Datakey Electronics, Inc. – Product Change Notification (PCN)

PCN Number: 20091216

Notification Subject: Change in enclosures for KeyLink/SlimLink series reader/writers

Current Reader/Writer Enclosure Box

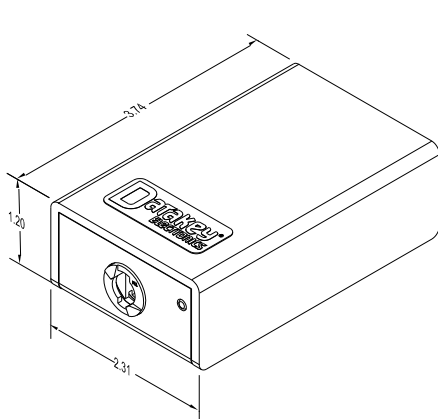
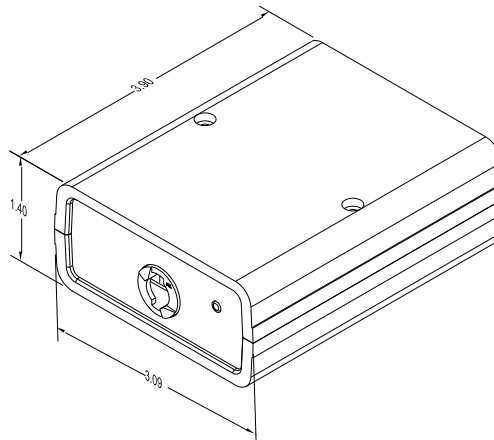
The reader/writer enclosure will be changed. The current enclosure (2.31”(w) x 3.74”(l) x 1.20”(h) – snap-fit) is being obsoleted and replaced with a new enclosure (3.09”(w) x 3.90”(l) x 1.40”(h) – screw fasteners).

This change affects the overall appearance only – no functionality of the reader/writers is being changed as part of this PCN. All product markings, details, and available label space will be transferred to the new enclosure.
